EXHIBIT "B"

AGENCY COMMENTS

DATE: 6/4/18 (Updated from 2/28/18)

RE: JANTZER (ANDERSON) SUBDIVISION AT HUDSON LANE: 36-06-13.A0/400 & 500
36-06-13.B0/200

REVISION	DATE	BY		TYPICAL SECTION RURAL RESIDENTIAL JOSEPHINE COUNTY PUBLIC WORKS	FIGURE #R	
					DATE 6/27/2007	SCALE: NTS
					DRAWN BY: RTP	CHECKED BY: CAD
				COUNTY ENGINEER: CHARLES DEJANNEER PE

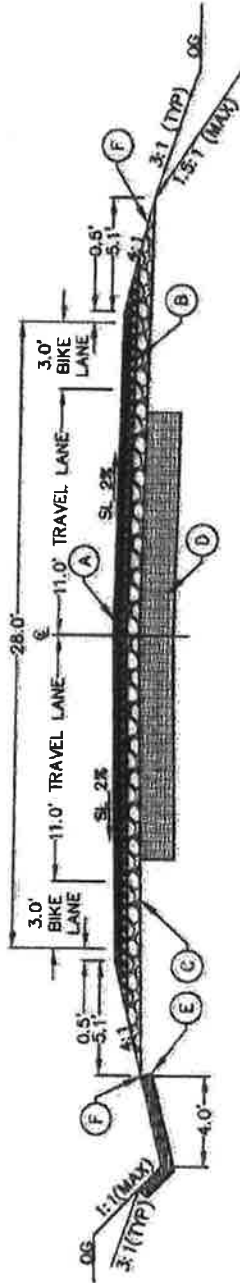
- 1) Prior to Tentative Plan Approval, the applicant shall ensure that Hudson Lane meets the Rural Residential requirements listed in the Road Data Summary Table 201.2 of the Josephine County Public Works Design and Construction Standards and Specifications Manual as the Tentative Plan indicates the proposed extension of Hudson Lane is to be Rural Residential. See the attached "RR" diagram from the Design and Construction Manual; this should be the diagram shown on Page T2 of the submitted plans.
